Drawing Title
COVER SHEET

PROPOSED MIXED USE DEVELOPMENT

47-50 THE ESPLANADE ETTALONG BEACH

S75W SUBMISSION

UPPER GROUND
FLOOR PLAN

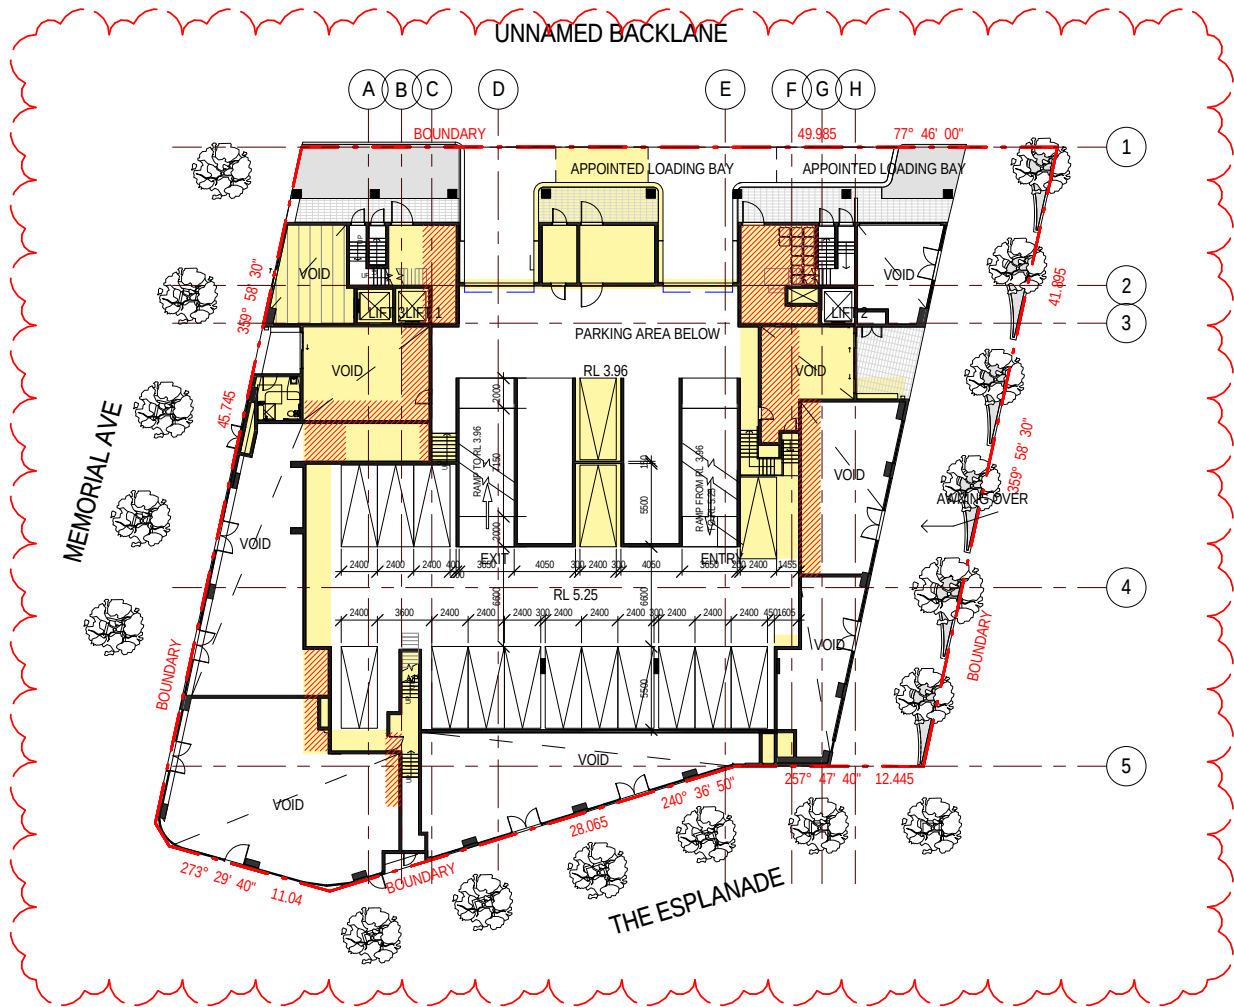
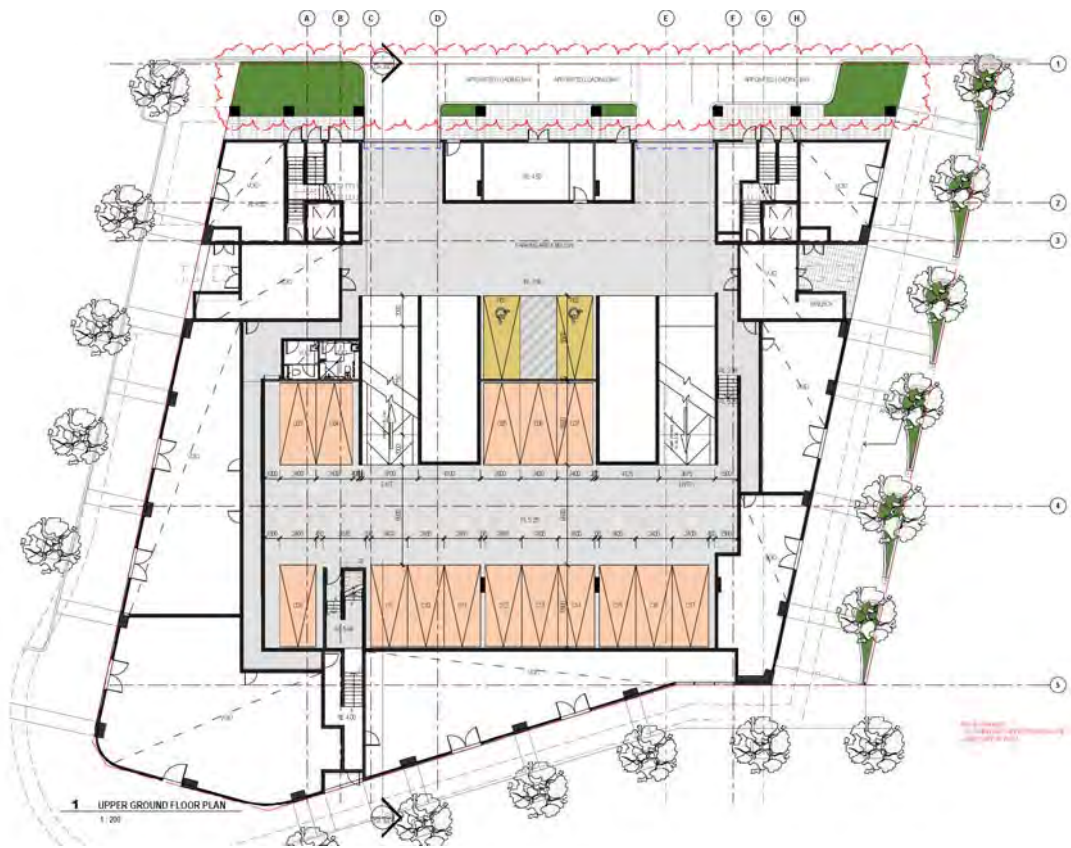
- RETAIL 1 CONVERTED TO PRIVATE LOBBY
- LIFT03 ADDED / LIFT01 RELOCATED
- CARPARK LAYOUT REVISED
- GARBAGE ROOMS REVISED / CARPARK EXHAUST REVISED
- COMMERCIAL AREAS REVISED
- CARPARK SCHEDULE REVISED
- ACCESSIBLE TOILET REVISED
- SECTION LINE RELOCATED
